AMENDMENT 2 AMENDEMENT 2

**Electromagnetic compatibility (EMC) –
Part 3-2: Limits – Limits for harmonic current emissions (equipment input
current ≤ 16 A per phase)**

This amendment has been prepared by subcommittee 77A: Low-frequency phenomena, of IEC technical committee 77: Electromagnetic compatibility.

Figure 2 – Illustration of the relative phase angle and current parameters described in 7.3 b)

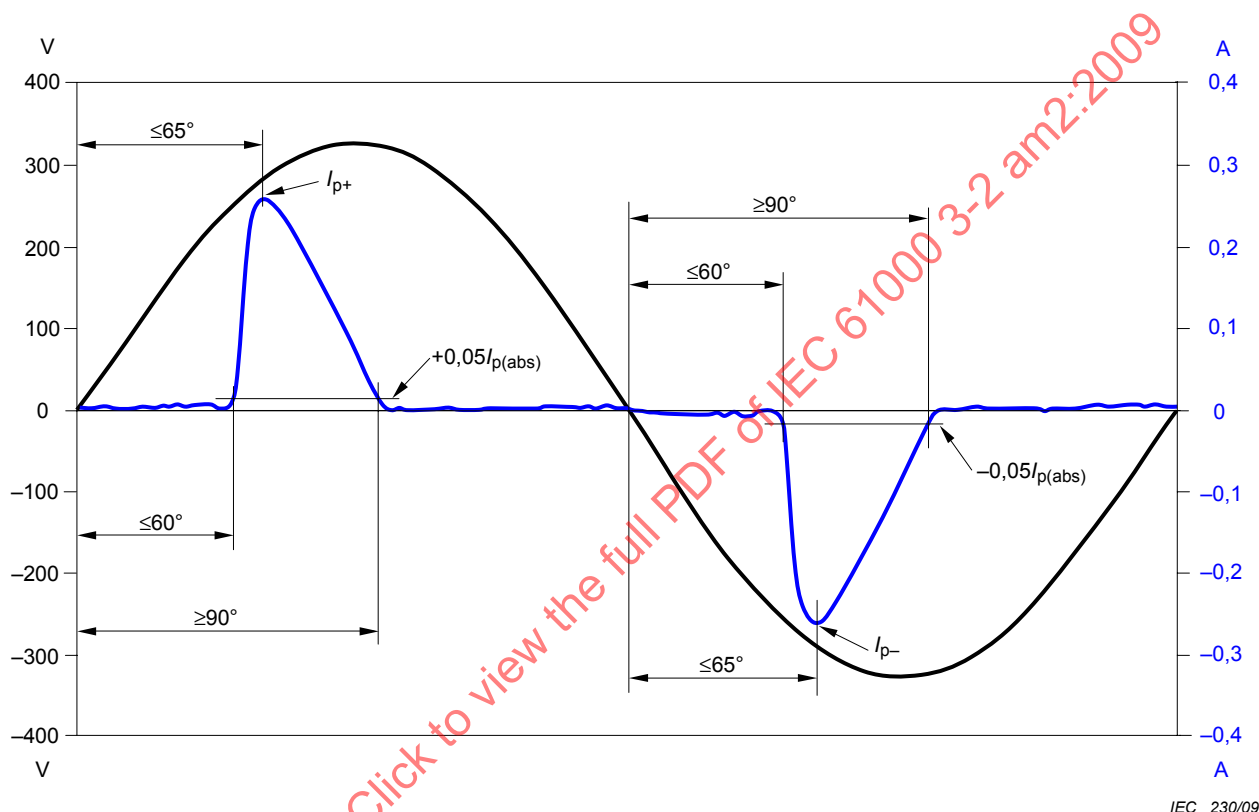
Replace the whole existing text of the second dashed item by the following new text:

- the third harmonic current, expressed as a percentage of the fundamental current, shall not exceed 86 % and the fifth harmonic current shall not exceed 61 %. Also, the waveform of the input current shall be such that it reaches the 5 % current threshold before or at 60°, has its peak value before or at 65° and does not fall below the 5 % current threshold before 90°, referenced to any zero crossing of the fundamental supply voltage. The current threshold is 5 % of the highest absolute peak value that occurs in the measurement window, and the phase angle measurements are made on the cycle that includes this absolute peak value. See Figure 2.

Add the following new Figure 2 after Figure 1:

NOTE $I_{p(abs)}$ is the higher absolute value of I_{p+} and I_{p-} .

Figure 2 – Illustration des caractéristiques en déphasage relatif et en courant décrites en 7.3 b)

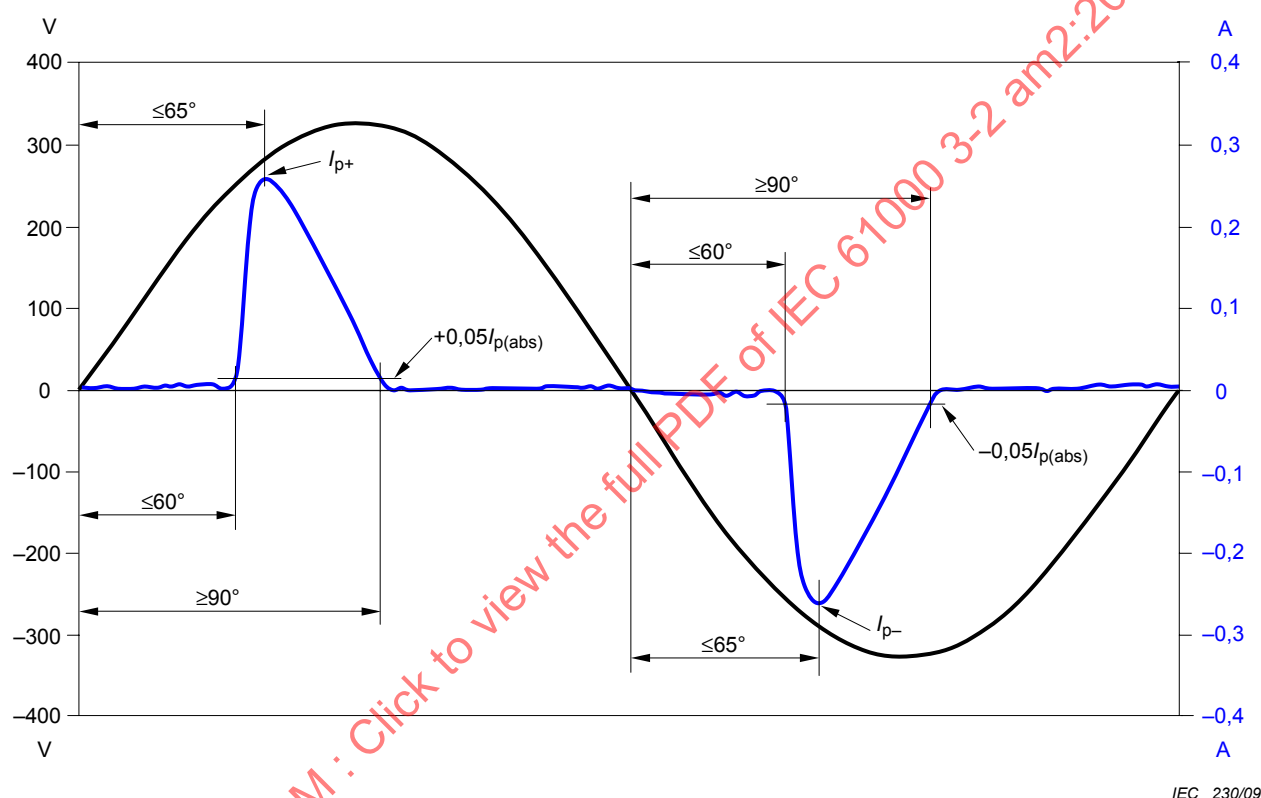
Remplacer l'intégralité du texte existant du second tiret par le nouveau texte suivant:

- l'amplitude du courant harmonique de rang 3, exprimée en pourcentage du courant fondamental, ne doit pas dépasser 86 % et l'amplitude du courant harmonique de rang 5 ne doit pas dépasser 61 %. De plus, la forme d'onde du courant d'entrée doit être telle qu'elle atteigne le seuil de 5 % en courant à 60° ou avant, qu'elle ait sa valeur de crête à 65° ou avant et qu'elle ne retombe pas en dessous du seuil de 5 % en courant avant 90°, par référence à n'importe quel passage par zéro du fondamental de la tension d'alimentation. Le seuil en courant correspond à 5 % de la valeur absolue la plus élevée de la valeur de crête qui se produit dans la fenêtre de mesure, et les mesures de déphasages sont faites sur la période qui inclut cette valeur absolue de la valeur de crête. Voir Figure 2.

Ajouter après la Figure 1 la nouvelle Figure 2 qui suit:

NOTE $I_{p(abs)}$ est la valeur absolue maximale de I_{p+} et I_{p-} .
